**SUBJECT:** R.E. Ginna Nuclear Power Plant  
Docket No. 50-244

**Supplemental Response to Requests for Additional Information Regarding  
Topics Described by Letters Dated August 24, 2005 and October 28, 2005**

ATTACHMENT 2  
RESPONSES TO NRC RAIs 2, 3, 5 REGARDING POST-LOCA LONG-TERM COOLING  
OCTOBER 28, 2005

ATTACHMENT 3  
RESPONSES TO NRC RAIs REGARDING LOCA ANALYSES  
AUGUST 24, 2005

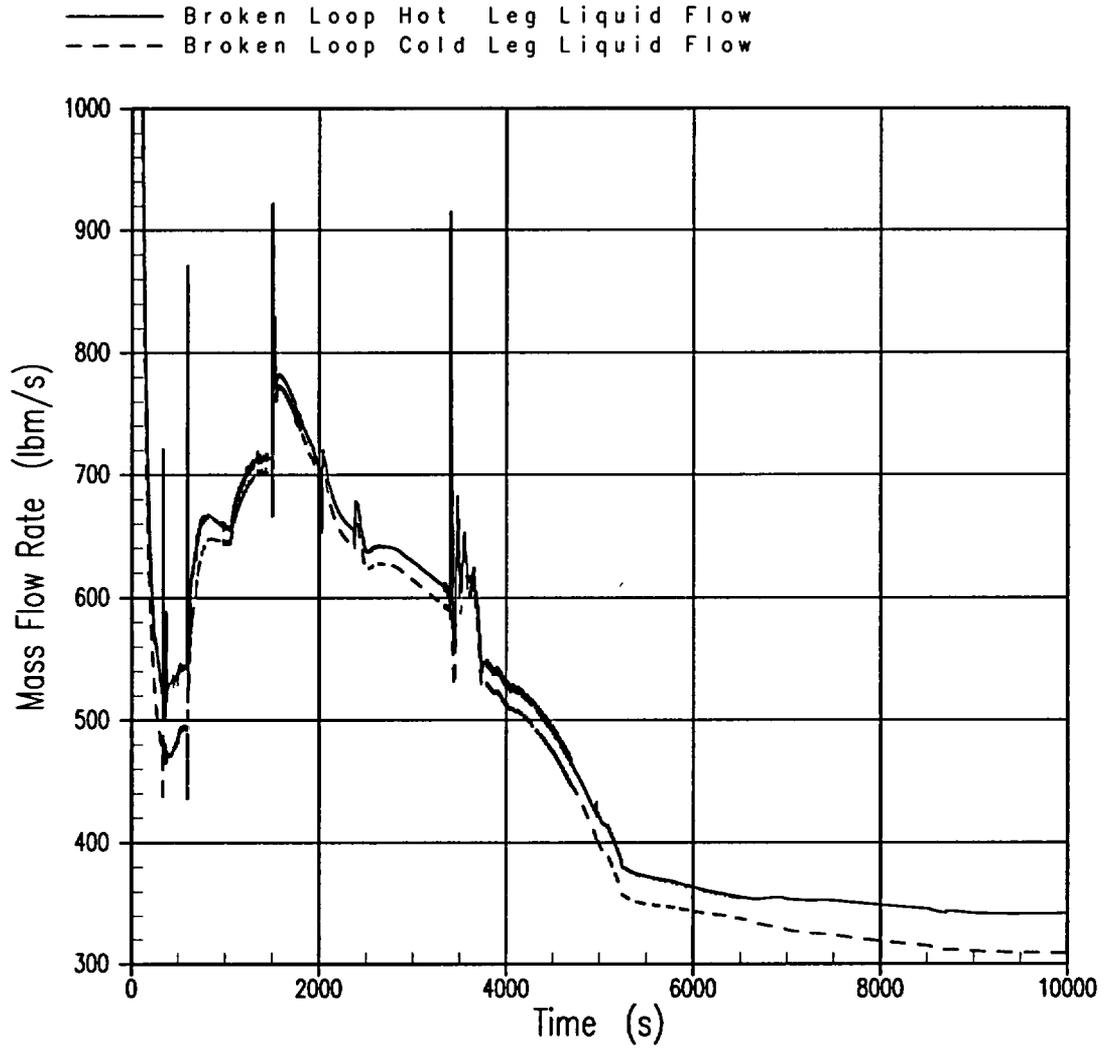
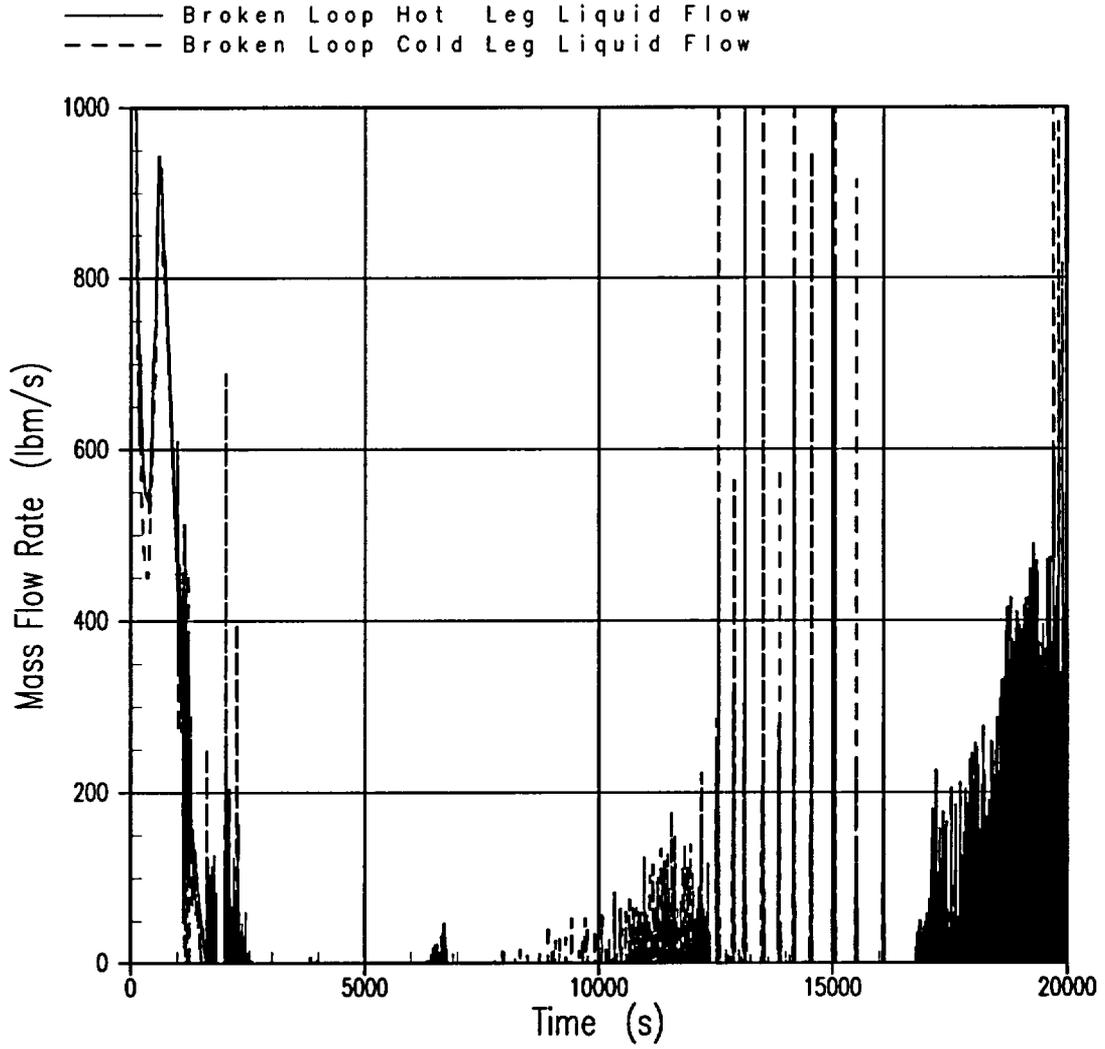
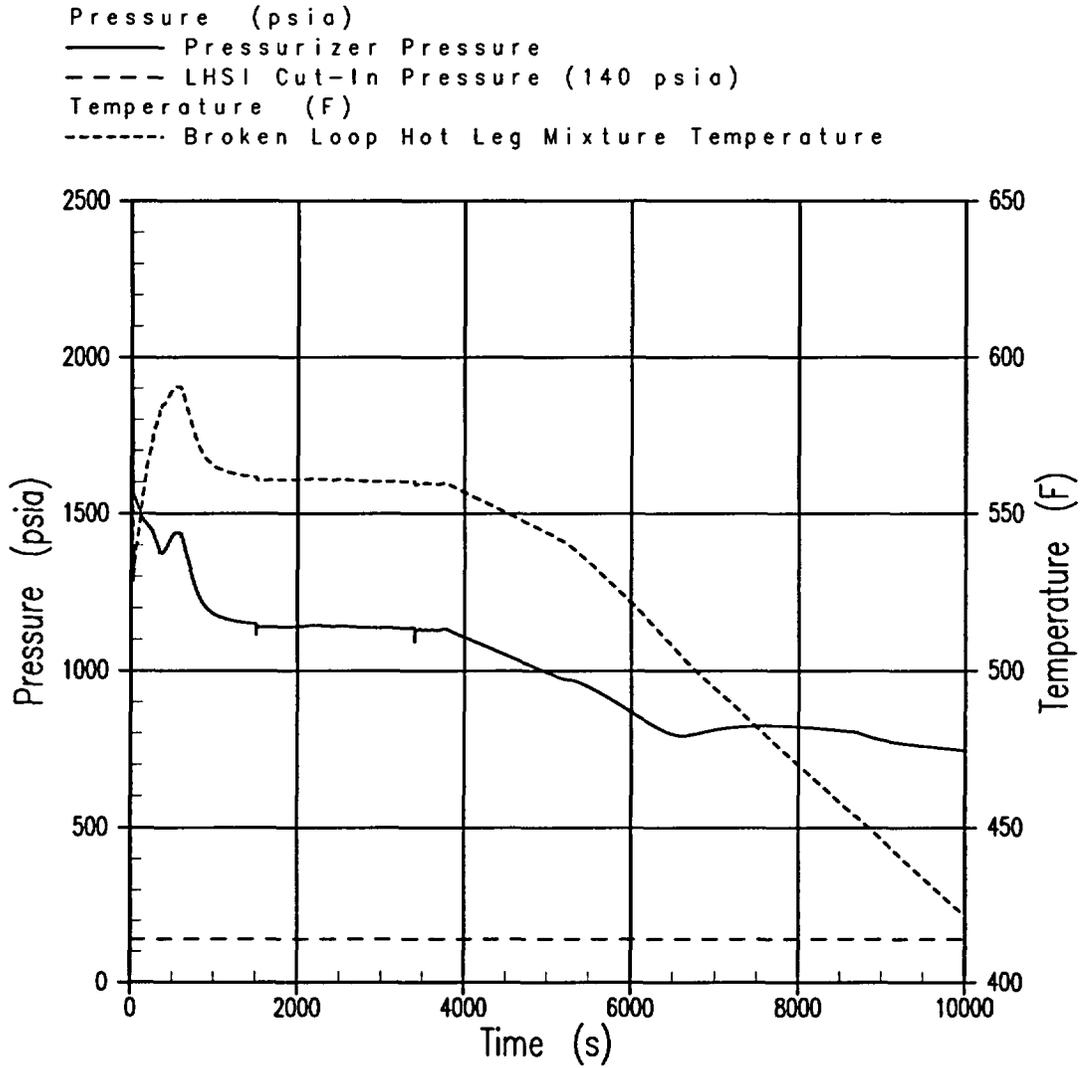
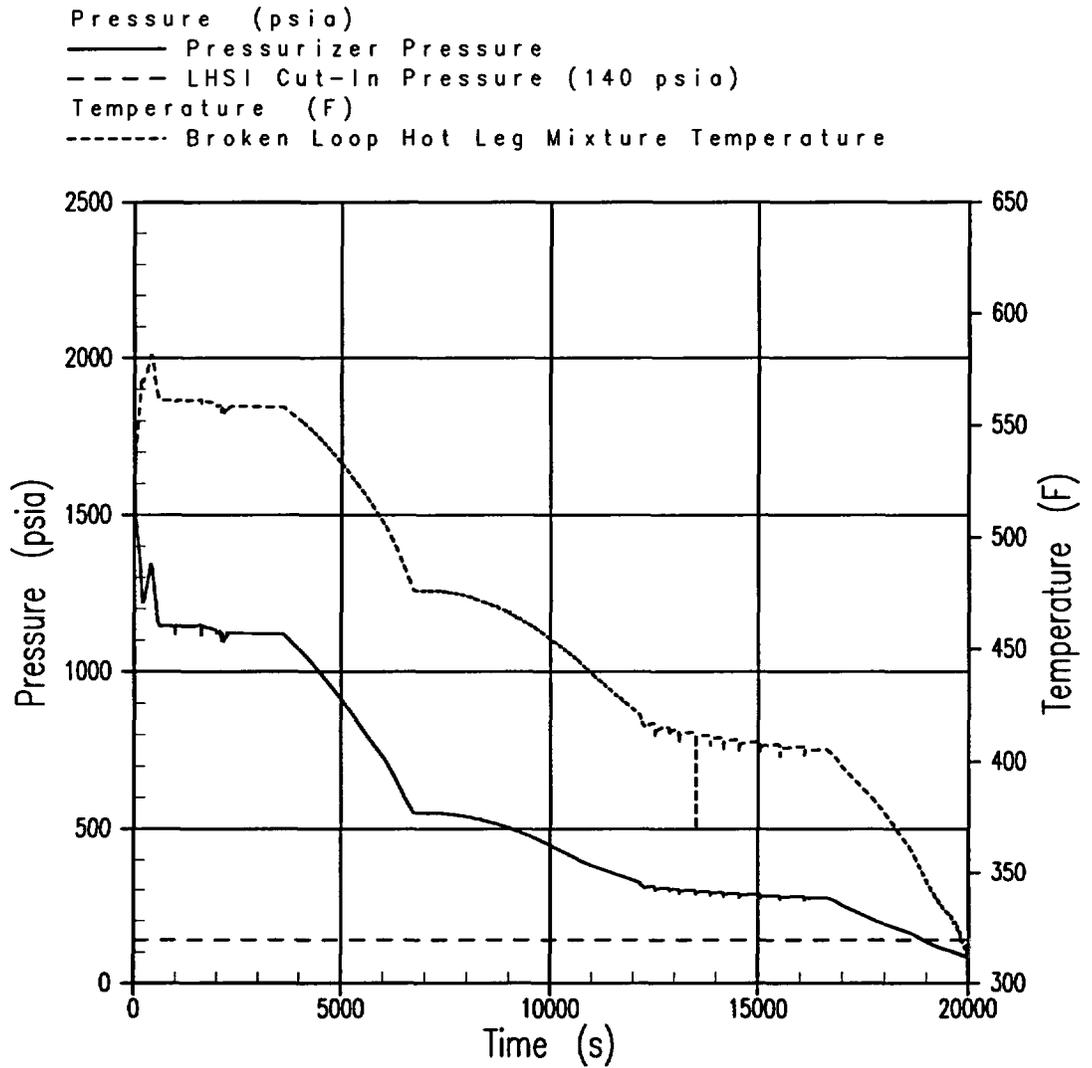
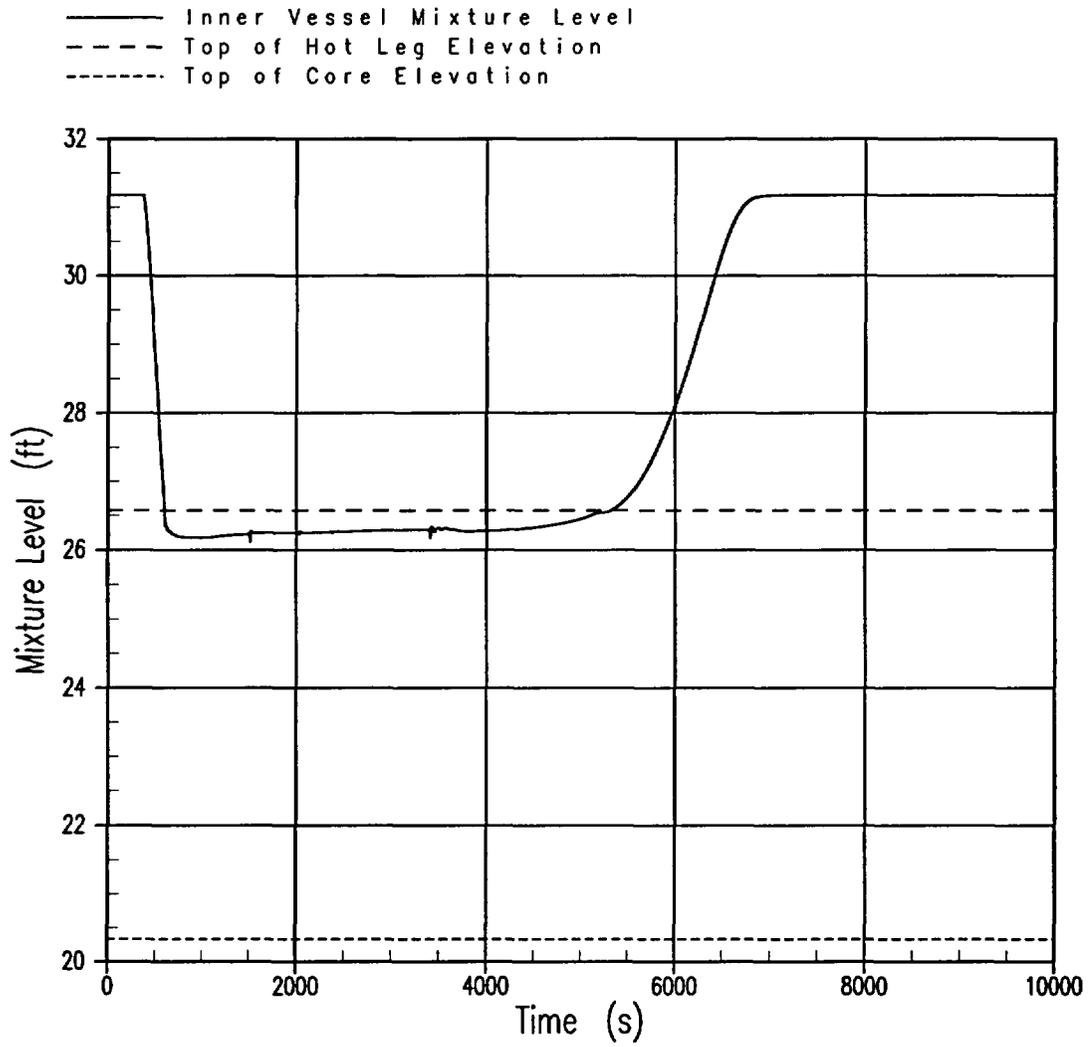
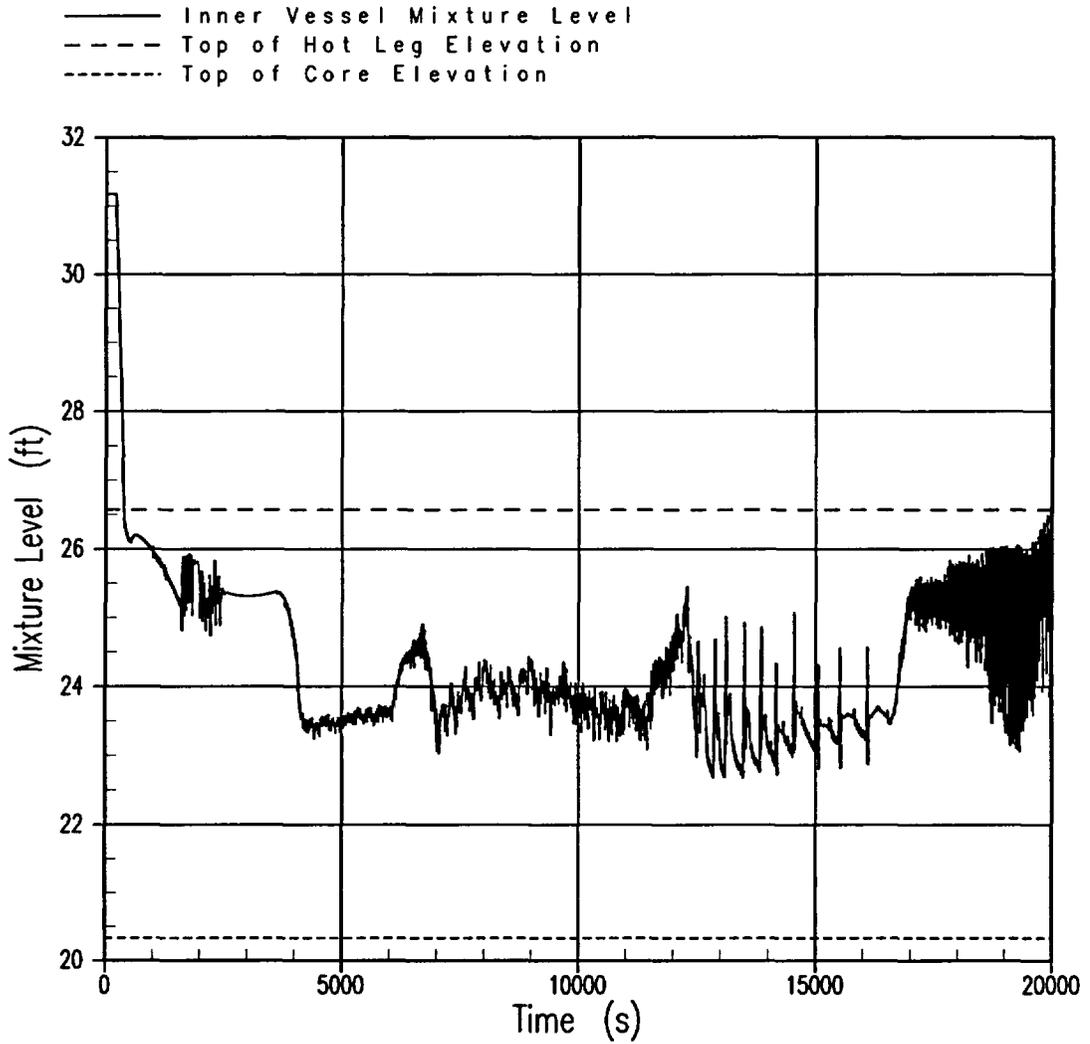
3. Provide information to show that for the largest break that does not actuate upper plenum injection (UPI) (where a cooldown is required) that there is sufficient time to perform this function given an appropriate precipitation time based on consideration of the four items in item 1 above.

Based on the results of these studies, it was determined that breaks approximately 0.8-inch equivalent diameter and less will not lose natural circulation, whereas larger ones will. It is quite possible that during the cooldown process these larger breaks could potentially regain natural circulation at some point; however, there will be some break size where this does not occur. For Ginna, this occurs for approximately a 1.1-inch equivalent diameter break. Figures 8 and 9 show the broken loop hot leg and cold leg liquid flow for the 0.8-inch and 1.1-inch breaks, respectively. The pressurizer pressure and broken loop hot leg mixture temperature for these same breaks are shown in Figures 10 and 11 and the inner vessel mixture level is shown in Figures 12 and 13.

The 1.1-inch break demonstrates the cooldown aspects for breaks where natural circulation is lost and not regained. This break size establishes the maximum time required to cooldown and depressurize the RCS to the UPI cut-in pressure. This analysis shows that the operators will be capable of depressurizing the RCS to the UPI cut-in pressure within approximately 5 hours, 15 minutes after the break occurs assuming the cooldown begins within 1 hour after the break occurs.
